ENGINE - LP TURBINE - INCORPORATE REVISED (EGT) BRACKETS OF FLANGE P - CATEGORY CODE 4
- MOD.ENG-72-0007

V2500-ENG-72-0007

Replacement of Loop Clamp Brackets and Attaching Bolts (For Engines not Incorporating V2500-ENG-72-00-0050))

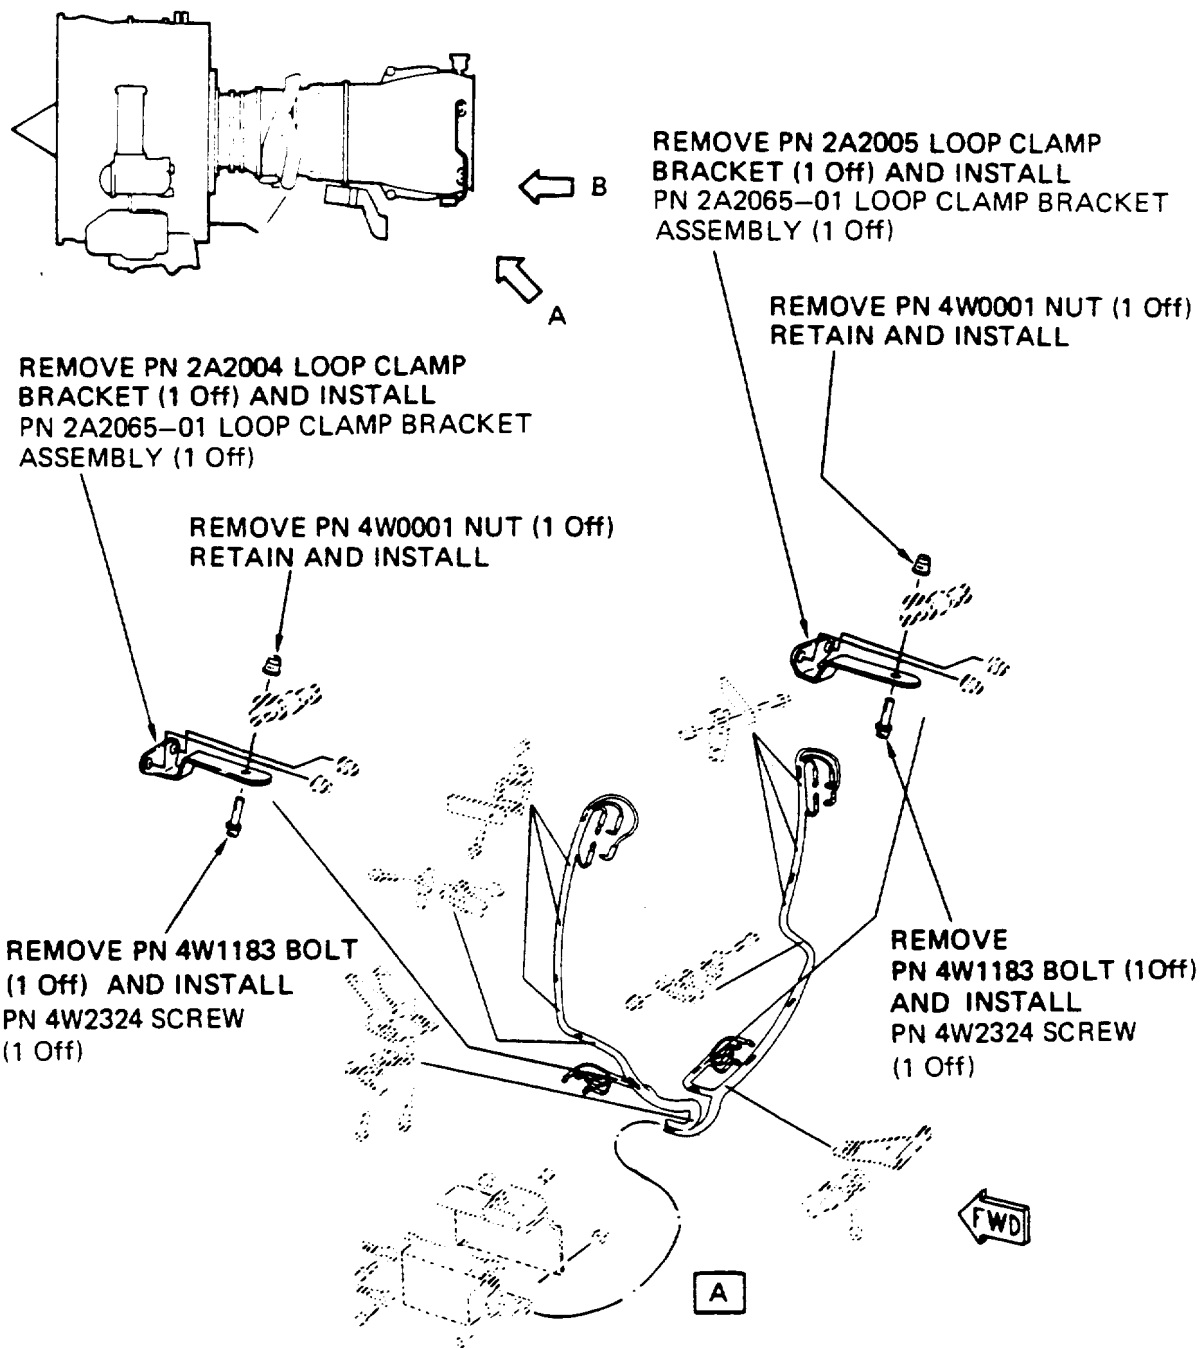
- (1) Remove the Nuts and Bolts which hold the two Loop Clamp Brackets 2A2004 and 2A2005 to the Loop Clamps
- (2) Remove the Nuts and Bolts which hold the 2A2004 and 2A2005 Loop Clamp Brackets to the Turbine Exhaust Case (Hole Locations 52, 53, 62 and 63). Refer to Figure 1.
- (3) Remove the Loop Clamp Brackets.

Replacement of Loop Clamp Brackets and Attaching Nuts (For Engines incorporating V2500-ENG-72-00-0050)

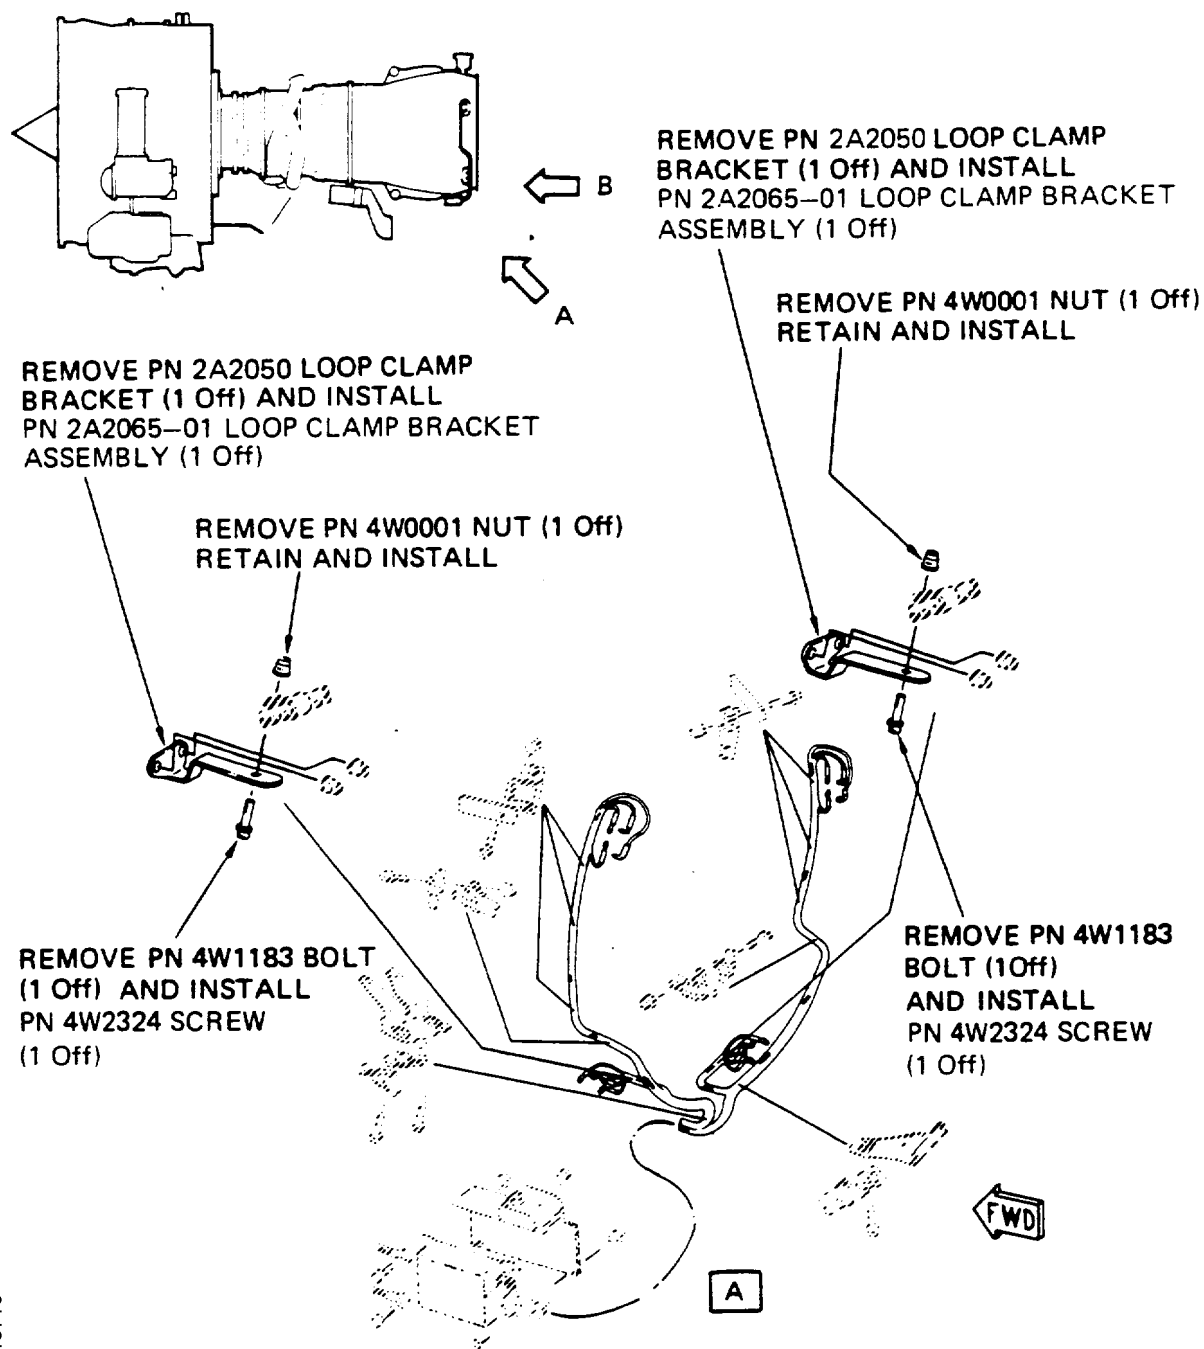
- (1) Remove the Nuts and Bolts which hold the two Loop Clamp Brackets 2A2050 to the Loop Clamps.
- (2) Remove the Nuts and Bolts which hold the 2A2050 Loop Clamp Brackets to the Turbine Exhaust Case (Hole Locations 52, 53, 62 and 63). Refer to Figure 1.
- (3) Remove the Clamp Brackets.

Replacement of Loop Clamp Brackets and Attaching Nuts (Assembly for all Engines to incorporate this Modification)

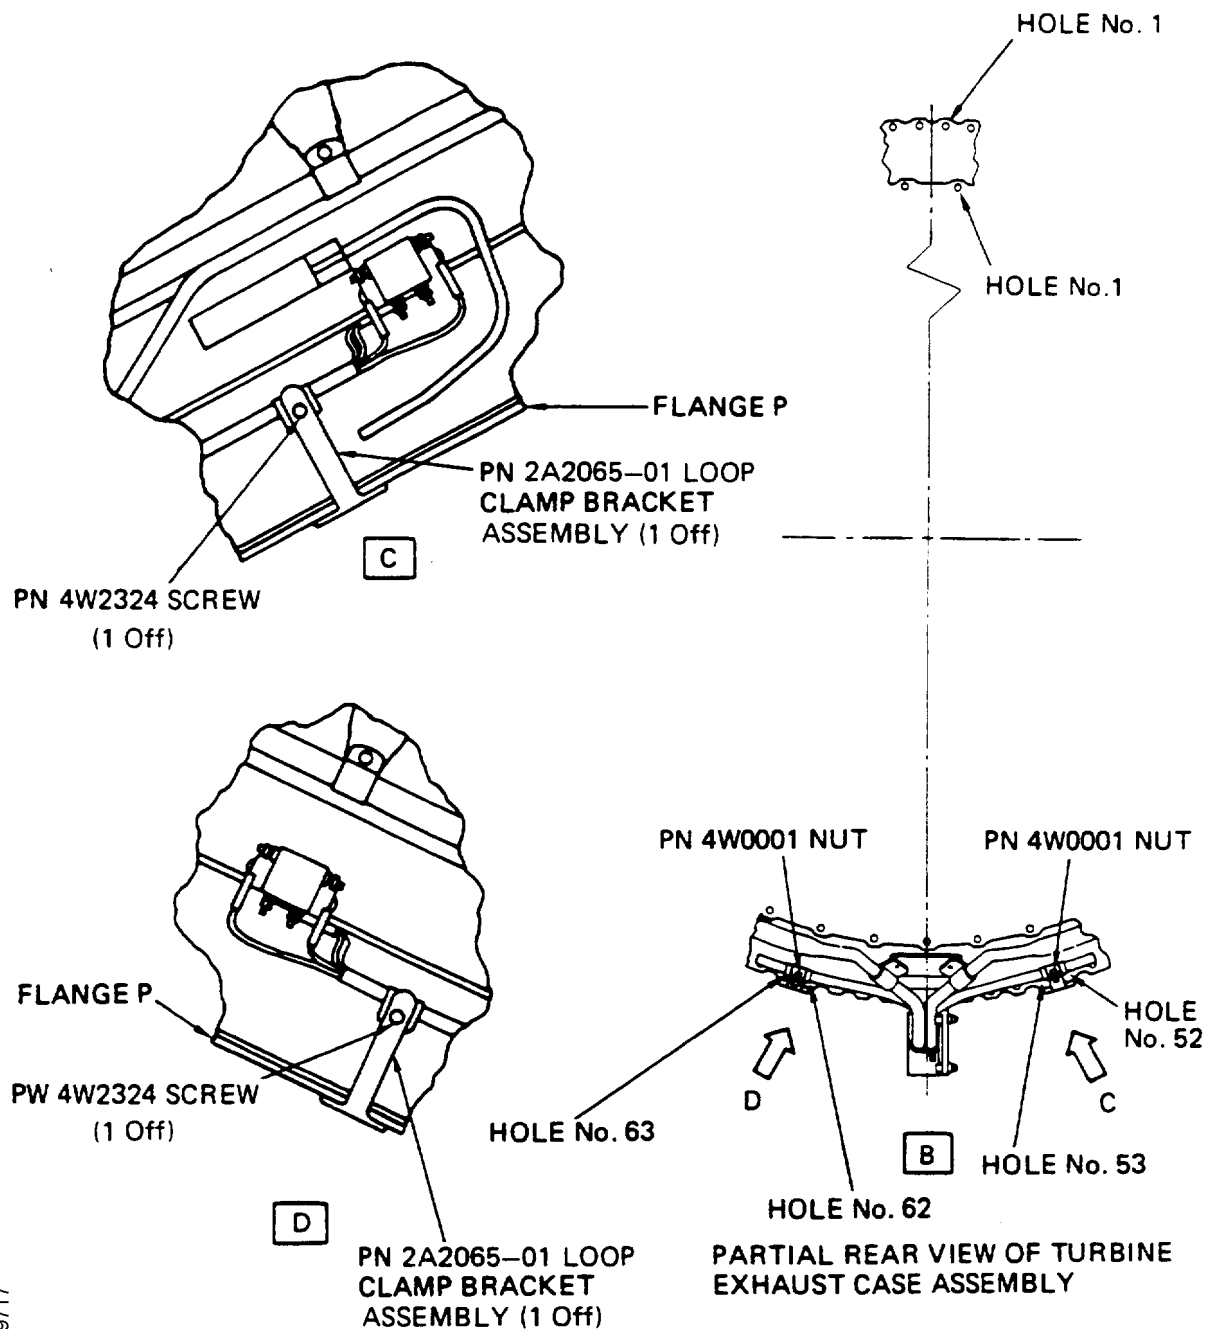
Provide new recontoured EGT Bracket Assemblies mounted on the front face of Flange P at holes 52 and 53 and 62 and 63. These Bracket Assemblies will prevent interference with the new rerouted No.4 Oil Weep Line and Hold Open Brackets.

- (1) The recontoured EGT Bracket Assemblies eliminate the interference with the new contoured No.4 Oil Weep Line and Hold Open Rod Brackets.

- (1) Lubricate the threads of 4W0001 Nuts (4 off) and the Bolts (which will hold the Brackets to the flange) with CoMat 10-039 Engine Oil.
- (2) Put the 2A2065-01 Loop Clamp Bracket Assembly (1 off) at the location of holes 62 and 63. Refer to Figure 1.
 - (a) Make sure that the bracket mount flange is forward of Flange P.
- (3) Install the Nuts and Bolts and tighten them with your hand.

- (4) Put the 2A2065-01 Loop Clamp Bracket Assembly (1 off) at the location of holes 52 and 53. Refer to Figure 1.

(a) Make sure that the bracket mount flange is forward of Flange P.

- (5) Install the Nuts and Bolts and tighten them with your hand.
- (6) Torque the Bolts to between 85 to 105 lbfin (9,60 to 11,86 Nm). See in Reference (3), Chapter/Section 70-41-00, Torque Tightening Technique.
- (7) Move the Loop Clamps so that the bolt holes in the Clamps align with the bolt holes in the Loop Clamp Brackets.
- (8) Lubricate the threads of the two 4W2324 Screws (2 off) and the Nuts, removed in step (2) of Paragraph c. or D. with CoMat 10-039 Engine Oil.
- (9) Install the Screws and Nuts and tighten them with your hand.
- (10) Torque the Screws to between 36 to 45 lbfin (4,07 to 5,08 Nm). See Reference (3), Chapter/Section 70-41-00, Torque Tightening Technique.
